## POWER TRIM - TRIM ACTION

*(Attach Bulletin Reference Sticker to P. 7A-1 of Your Service Manual.)*

**Figure 1. Harness Connector Identification**

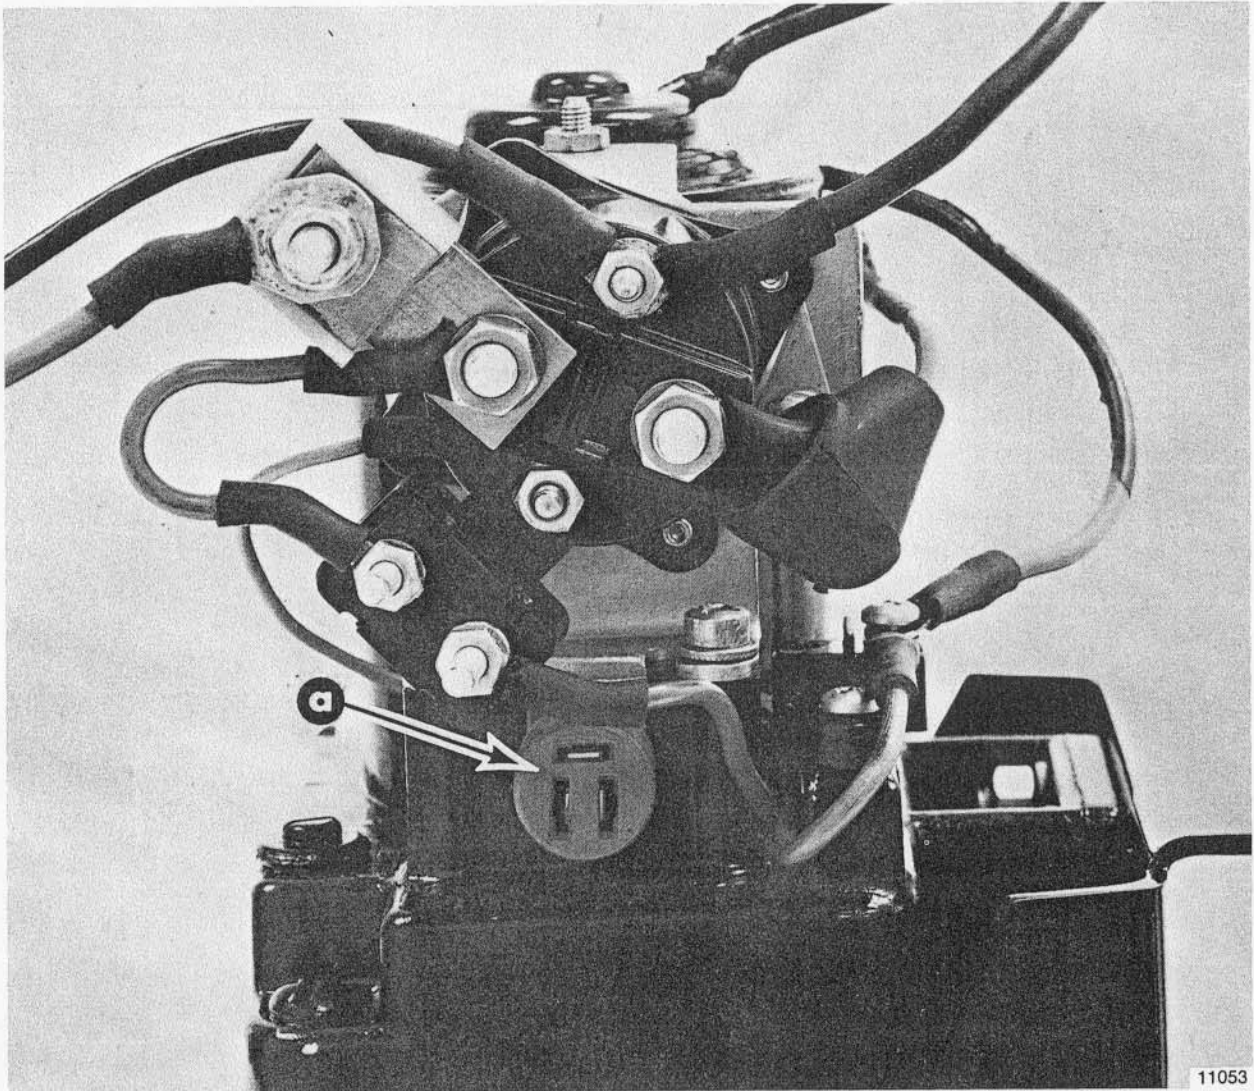
There is a possibility that some Power Trim pump assemblies with Harness Connector B-84-79147 (Figure 1) may have a shorted condition that could allow the Power Trim motor to actuate itself in the "up" direction.

If this symptom exists, check the harness connector for a shorted condition between the harness' three wires. If shorted, replace the connector and submit a properly completed warranty claim (including transom assembly Serial Number) and the connector to your Branch or Distributor for credit.
